## **Mekong River Commission**

### **PRIOR CONSULTATION PROCESS FOR THE SANAKHAM HYDROPOWER PROJECT**

#### **SUMMARY OF THE FINAL DRAFT OF THE TECHNICAL REVIEW REPORT**

**4 November 2021**

### ASSESSMENT OF THE SUBMITTED DESIGN

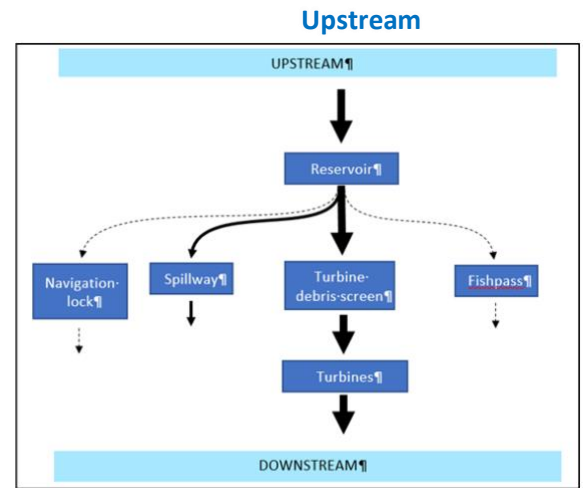
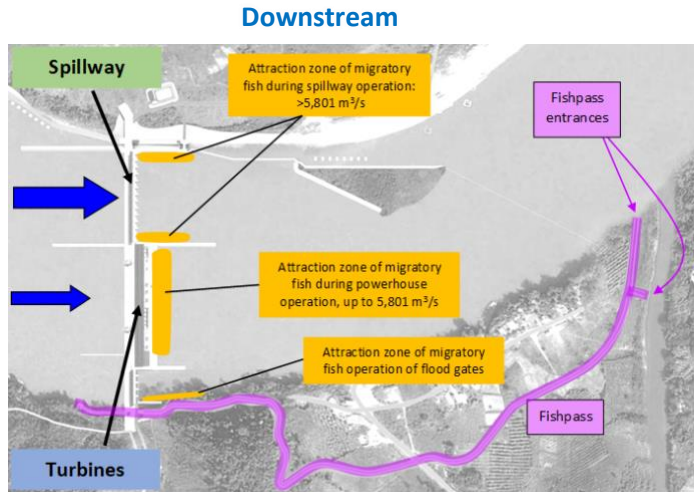
The developer has proposed a “nature-like” fishpass for upstream migration and turbines as the main passage for downstream migration. The “nature-like” concept has potential, but the overall design for upstream and downstream fish passage will not sustain migratory fish populations.
